FirstEnergy Nuclear Operating Company

Subject: Beaver Valley Power Station, Unit No. 1
Docket No. 50-334, License No. DPR-66
Updated Inservice Testing Program, Issue 3, Revision 4

SUMMARY OF CHANGES TO THE BVPS-1 IST PROGRAM (ISSUE 3, REV 4)

Pump Name: 1A Reactor Plant Water Pump

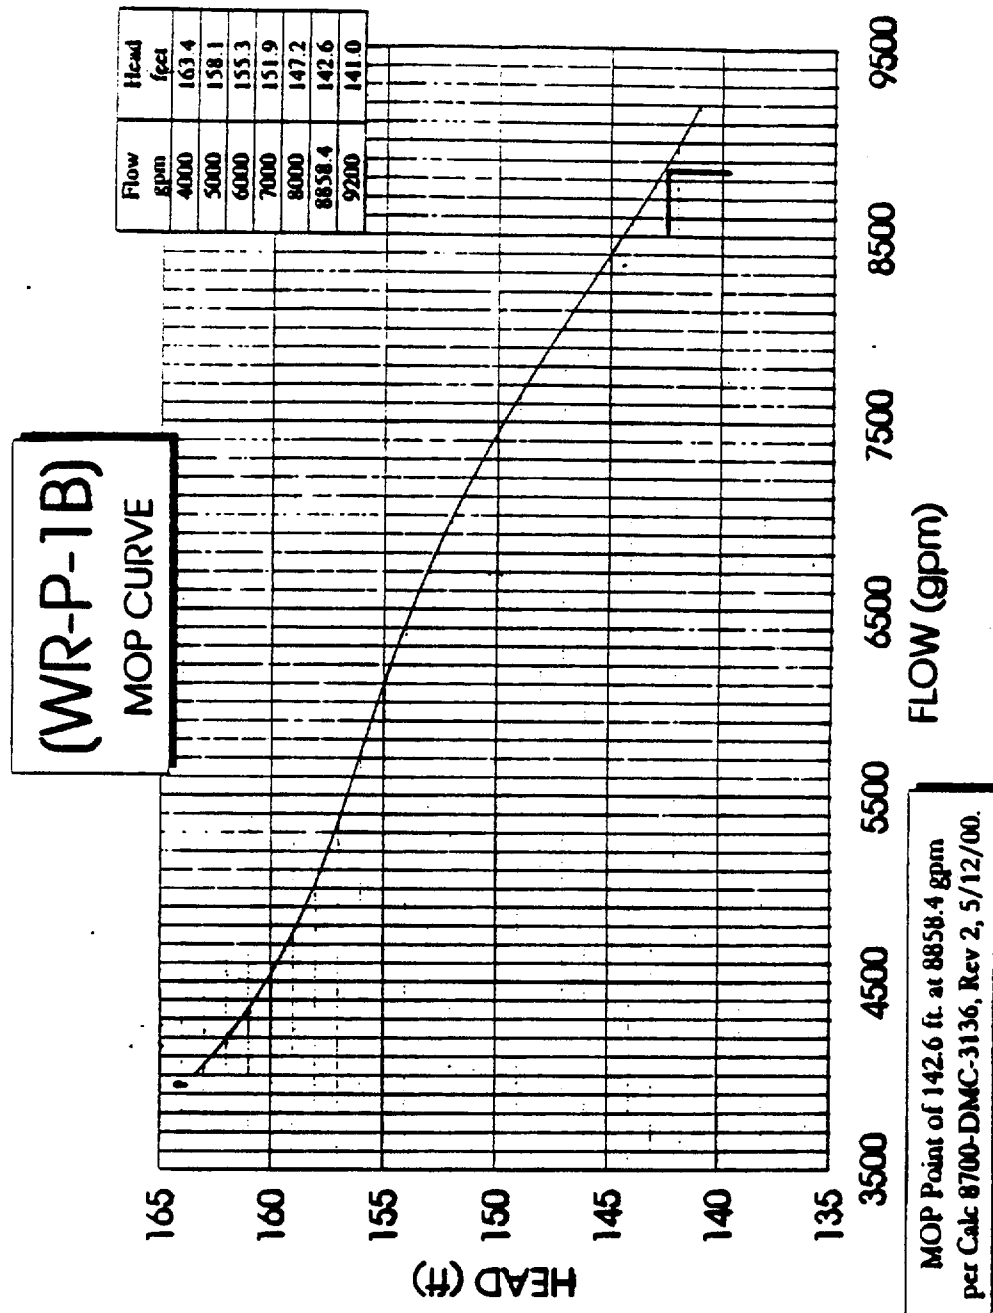
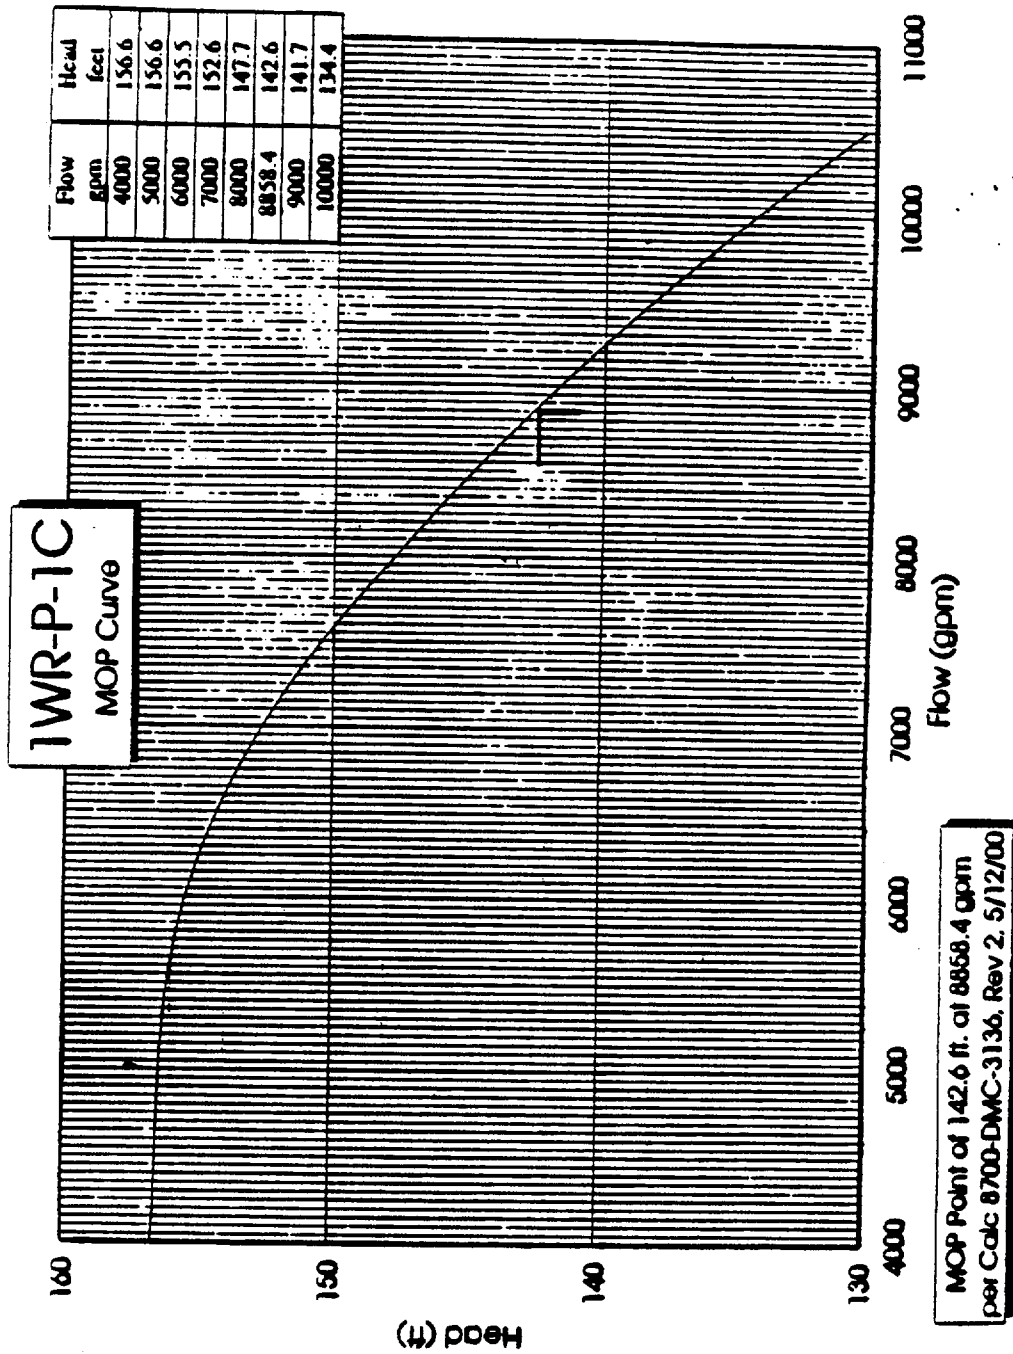
- A. Incorporated the new MOP curves for the Reactor Plant River Water Pumps, per TER 13249. The MOP point was lowered as a result of incorporating the test data from the thirteenth refueling outage full flow river water tests. (pg. 81, 82, 83)
